# Technical Service Bulletin

<b>Topic</b>	Rattle Rear Cabin Area - Seat Belt Assembly
<b>Market area</b>	Bentley: worldwide (2WBE)
<b>Brand</b>	Bentley
<b>Transaction No.</b>	2040267/2
<b>Level</b>	EH
<b>Status</b>	Released for publishing

Figure 1

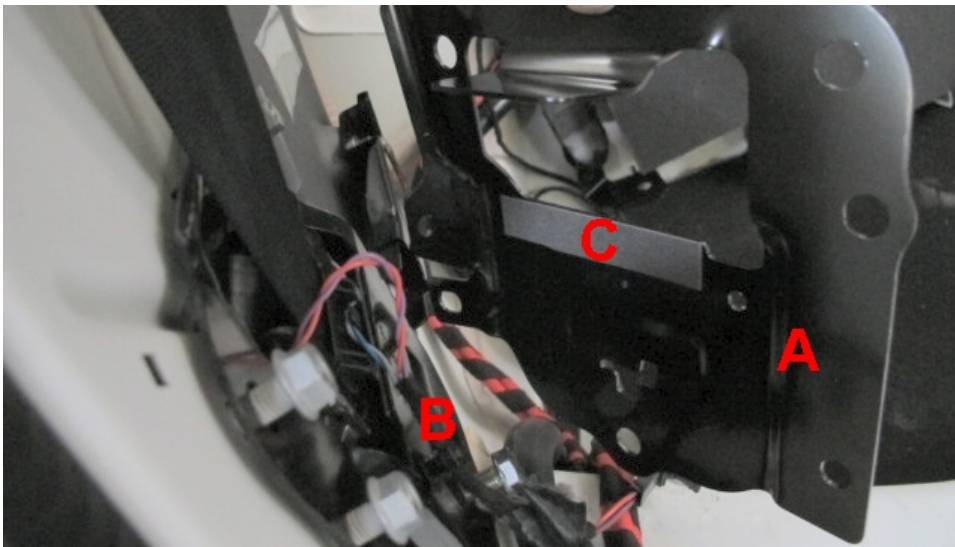
2. With the seat belt mounting plate (A) separated from the seat belt reel housing (B) apply isolation pad, part number 6N0971799 (C), to the inside face of the seat belt mounting plate (see Figure 1,2 and 3).

Figure 4

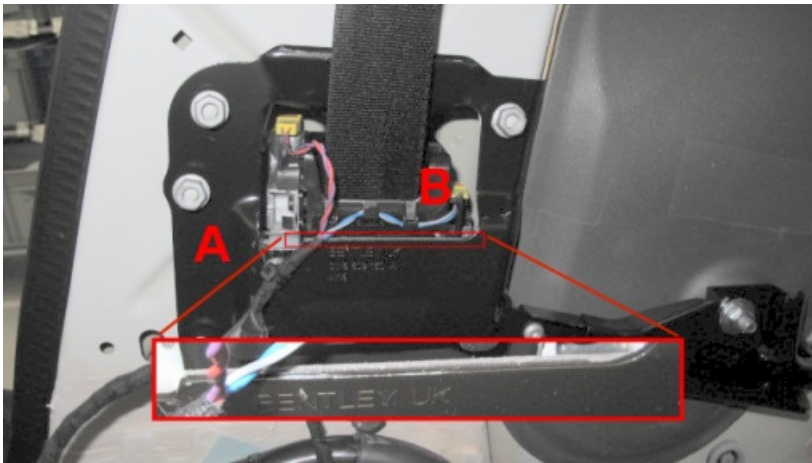
4. When refitted The isolation pad will be sandwiched between the seatbelt reel assembly (B) and the mounting plated A and should just be visible flush with the top of the aperture in the seat belt mounting plate (see Figure 4)
